**HORIZONTAL DIRECTIONAL DRILL ANALYSIS
HIGHWAY 222 CROSSING
PADEP SECTION 105 PERMIT NO.: E06-701
PA-BR-0071.0000-RD-16
(SPLP HDD No. S3-0200-16)**

ORIGINAL HORIZONTAL DIRECTIONAL DRILL DESIGN SUMMARY: 16-INCH

REVISED HORIZONTAL DIRECTIONAL DRILL DESIGN SUMMARY: 16-INCH

Figure 1. Permitted 16-Inch HDD Plan and Profile with 20-Inch IR Data

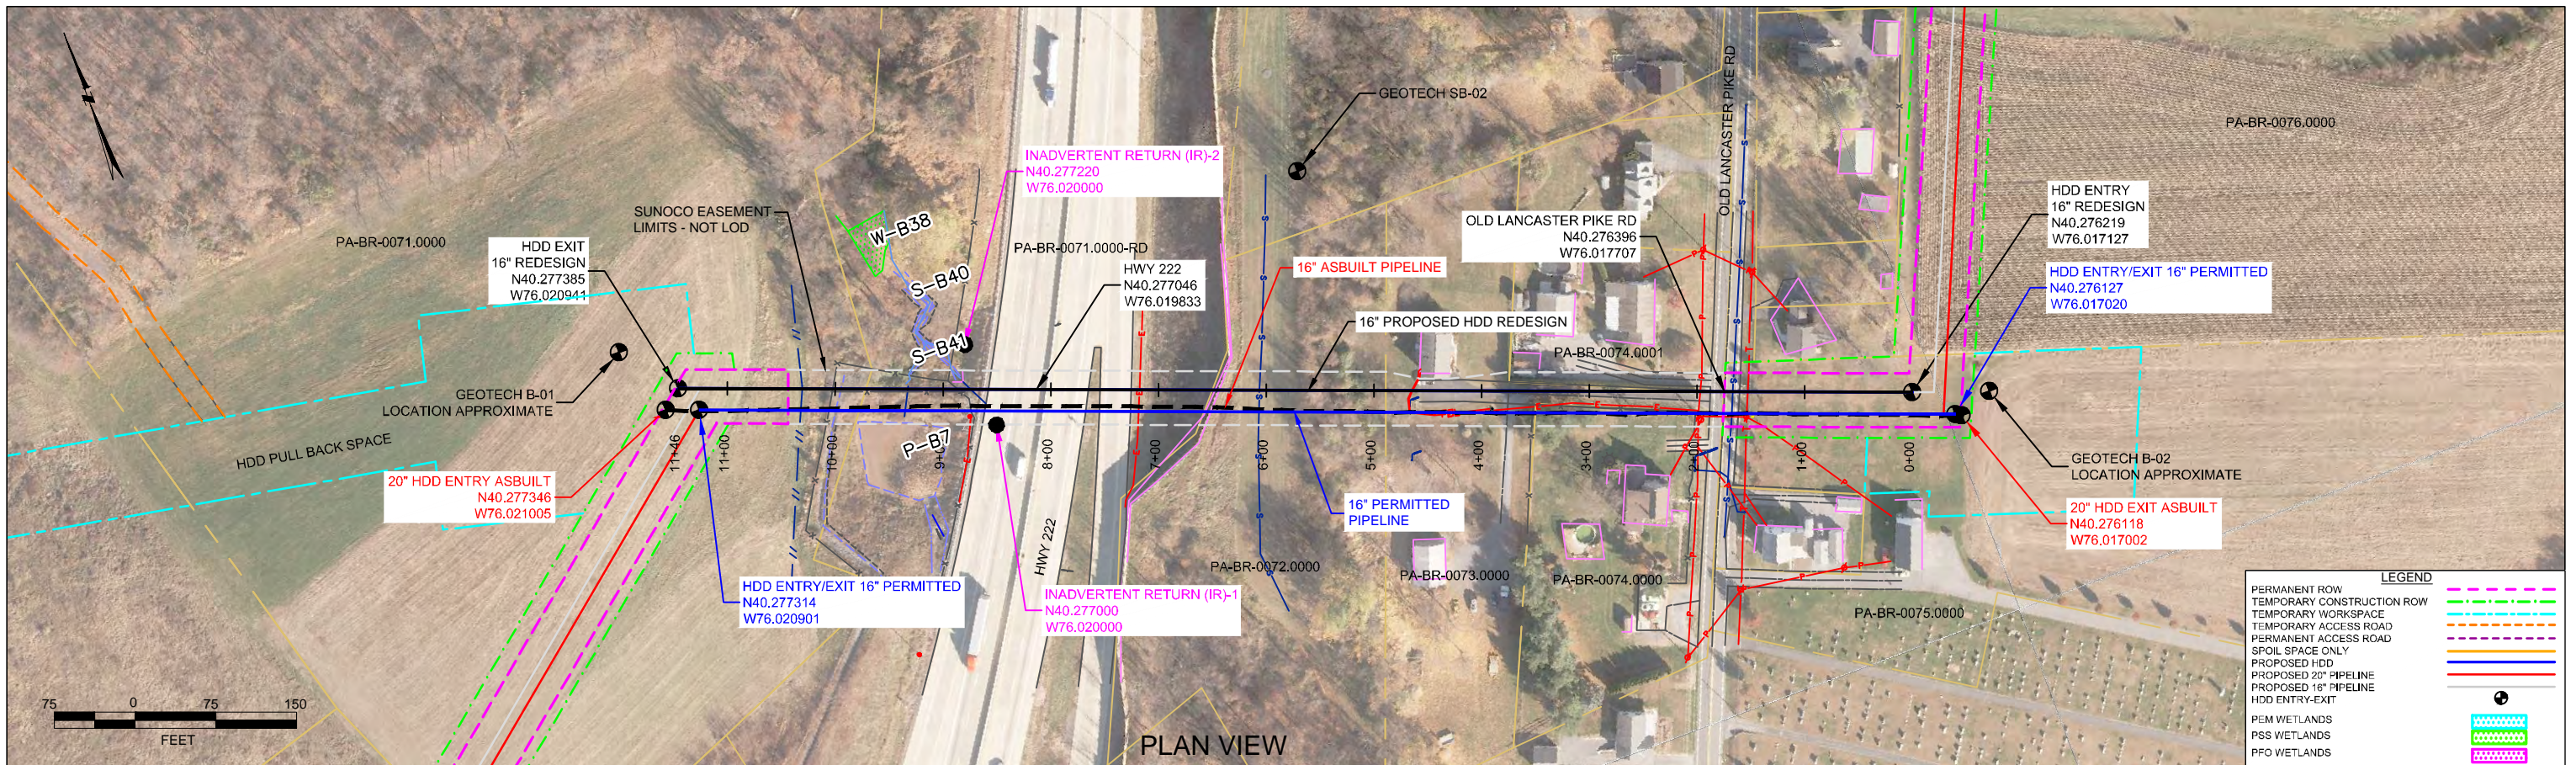
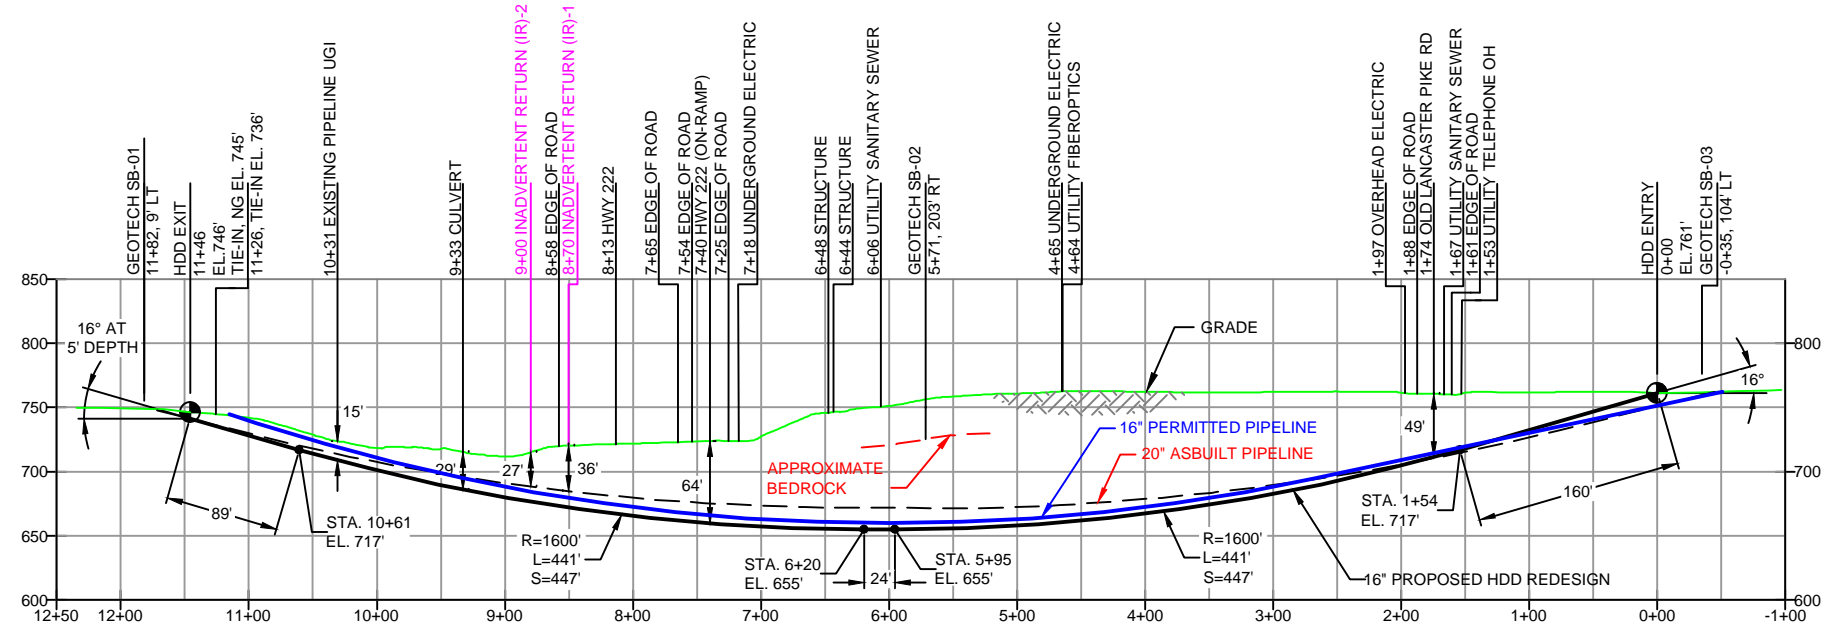
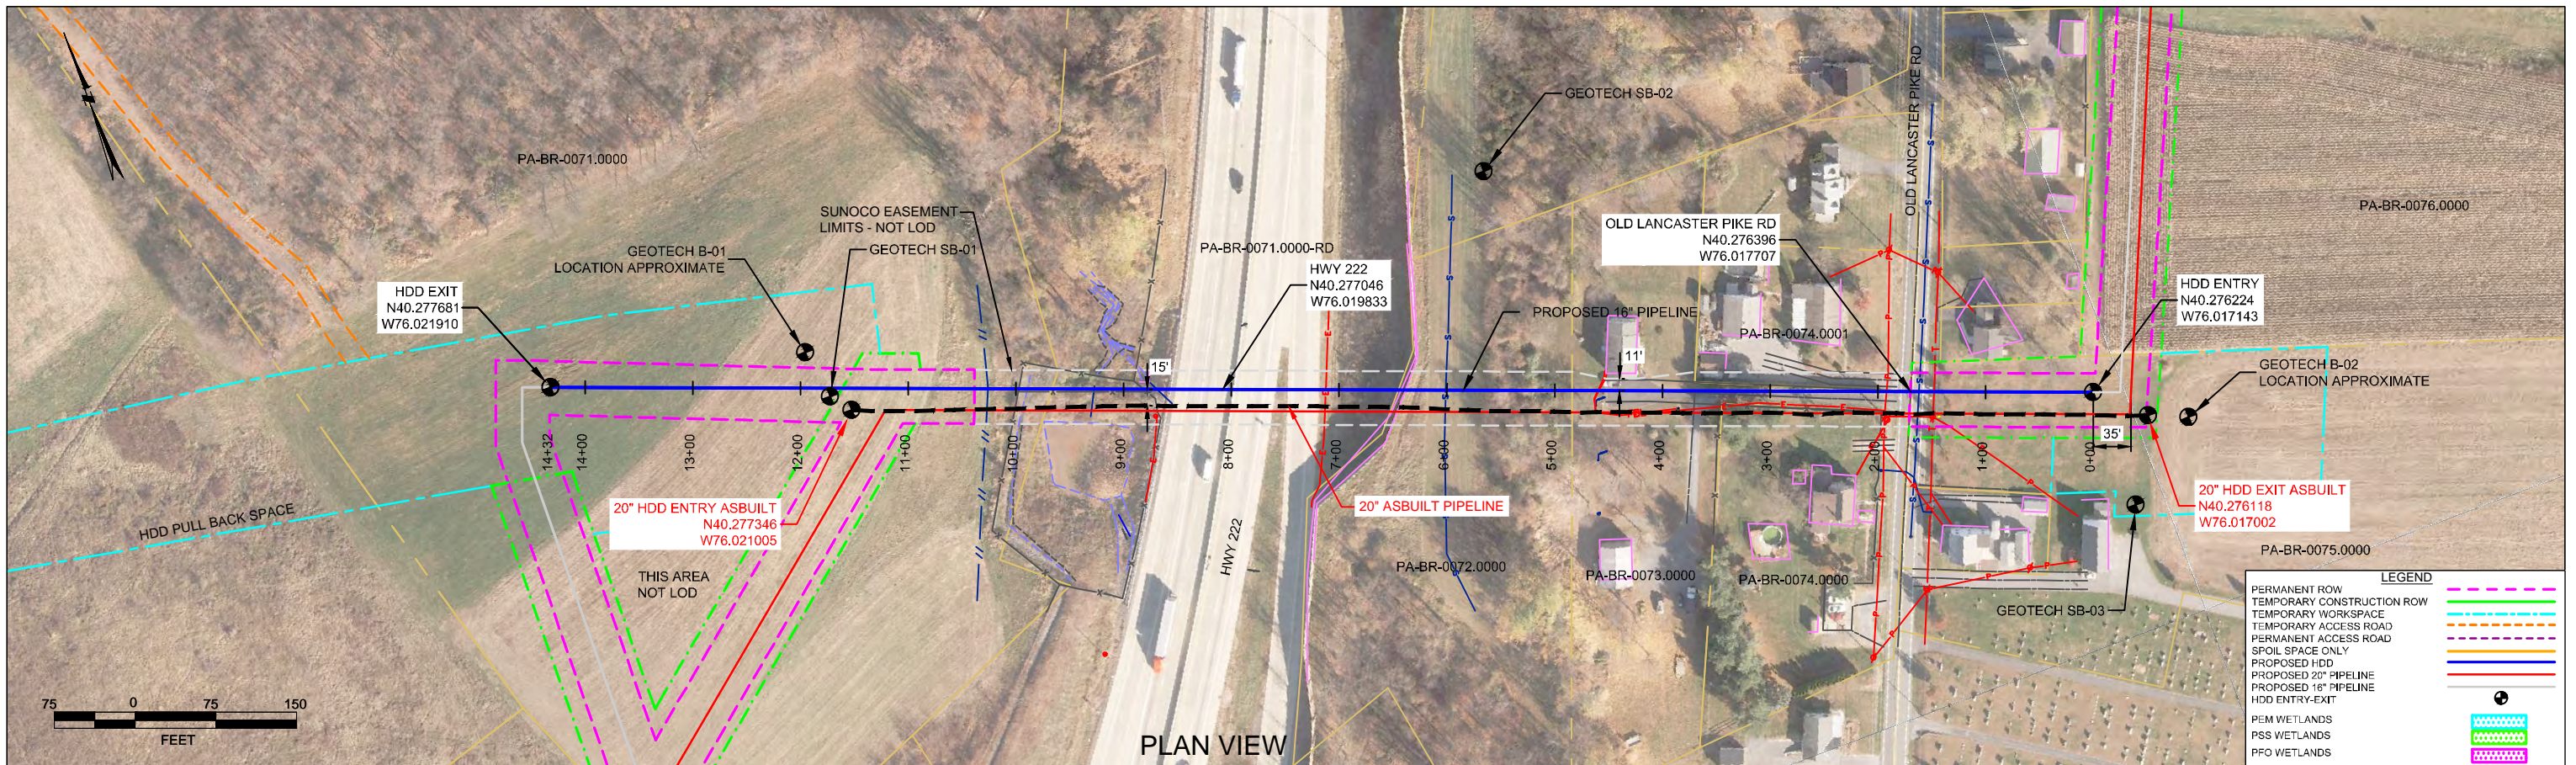
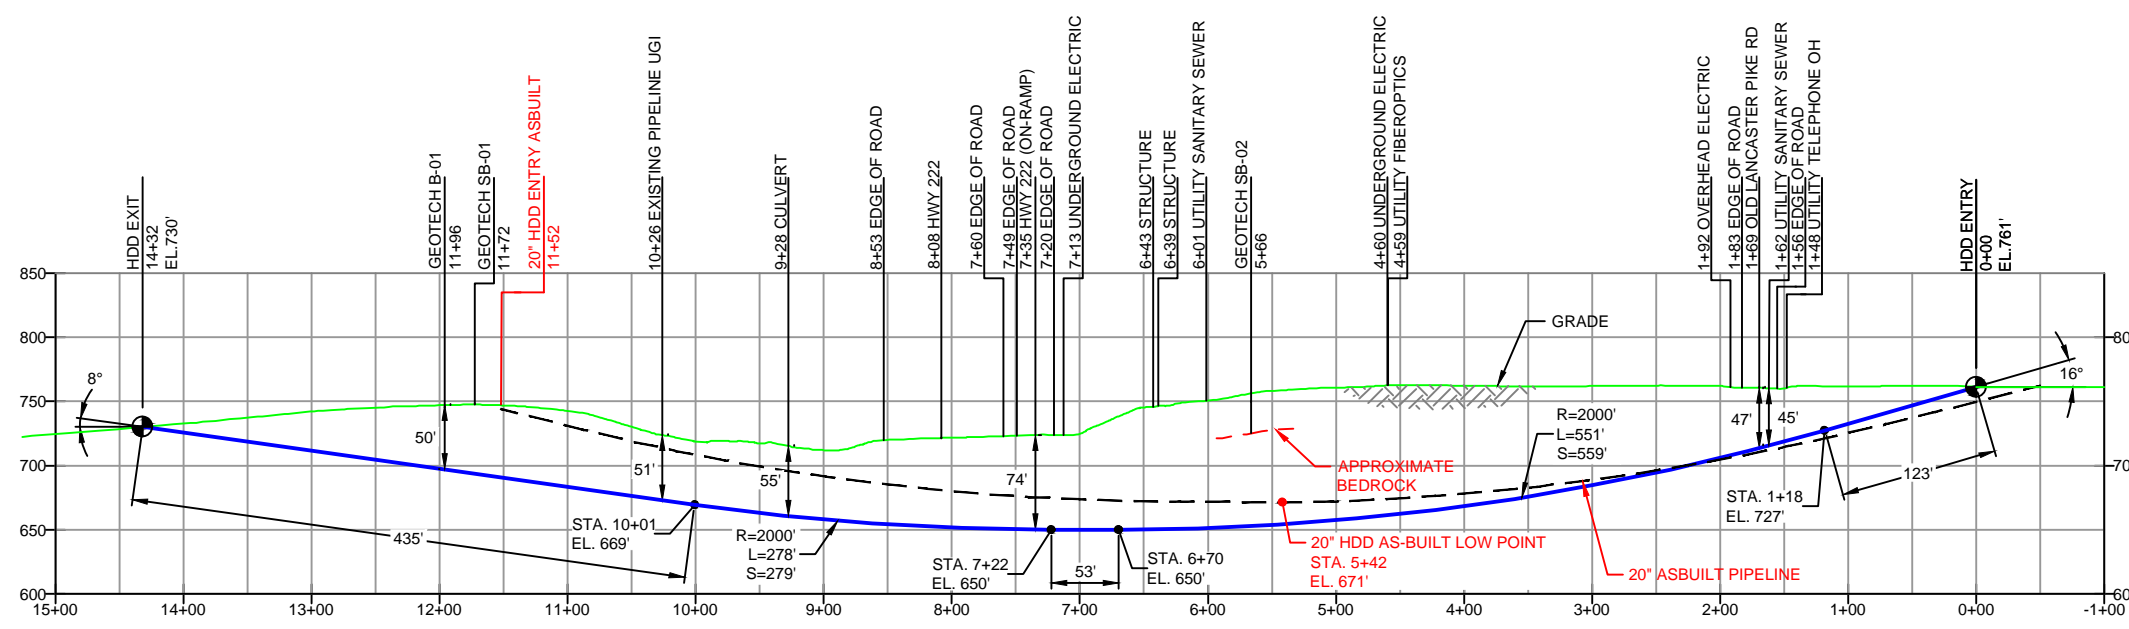
The occurrence of IRs reported during the drilling of the 20-inch line resulted from the shallow depth of the borehole profile, as well as the weathered nature of the bedrock in the area of the IRs. The IRs developed near the edge of the south bound lane of Highway 222 at HDD Stations 8+70 during the pilot phase and Station 9+00 during the reaming phase, when the drilling tools were within and/or above the weathered bedrock surface. The IRs ranged in depth of approximately 27 and 36 feet bgs. Based on the Rock Quality Designation (RQD) of the rock core (B-01) retrieved near the HDD Exit Location, the bedrock near the location of the IR was highly fractured to broken and significantly contributed to the occurrence of the IRs in this area.

HDD specialists for Sunoco Pipeline, L.P. (SPLP) reviewed the original 16-inch HDD design in combination with the data from the 20-inch pipeline installation and have concluded that that the design profile for the 16-inch HDD would likely produce an IR at the same location.

The profile for the 16-inch pipeline has been redesigned so that it is deeper than previously planned. By extending the HDD by 295 feet to the west and 50 feet to the east, the profile has been deepened to increase the maximum depth of the HDD by an additional 34 feet under the locations of the IRs that occurred during the 20-inch pipeline HDD. Proactive drilling Best Management Practices will be used to control Losses of Circulation to minimize the potential for IRs during drilling and installation of the 16-inch pipeline.

Figure 2. Redesigned 16-Inch HDD Plan and Profile

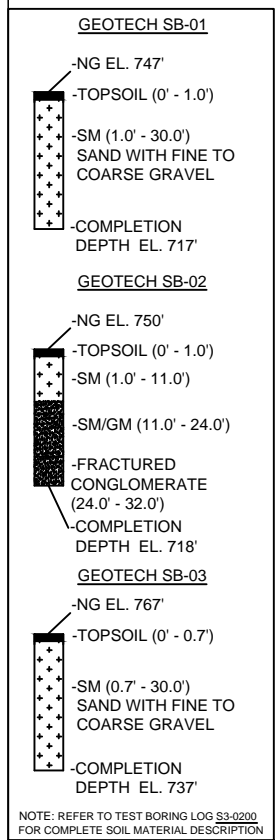
As shown on Figure 2 in Attachment 2, the redesigned HDD profile for the 16-inch pipeline is 326 ft longer, with a depth of cover under the previous IR location increased by 35 ft from the permitted design.

Additional geologic investigation has been completed, and the “as built” record for the 20-inch pipeline has been utilized in the redesign of the planned 16-inch HDD. The redesign adjusts the HDD profile deeper to minimize the risk of drilling fluid loss, drilling difficulties, and IRs. A summary of the redesign factors is provided below. The original and redesigned 16-inch HDD plan and profile drawings are provided in Attachment 2.

- Horizontal length: 1,432 ft
- Entry/Exit angle: 8-16 degrees
- Maximum Depth of cover: 100 ft
- Depth under Stream B-41: 55 ft
- Pipe design radius: 2,000 ft
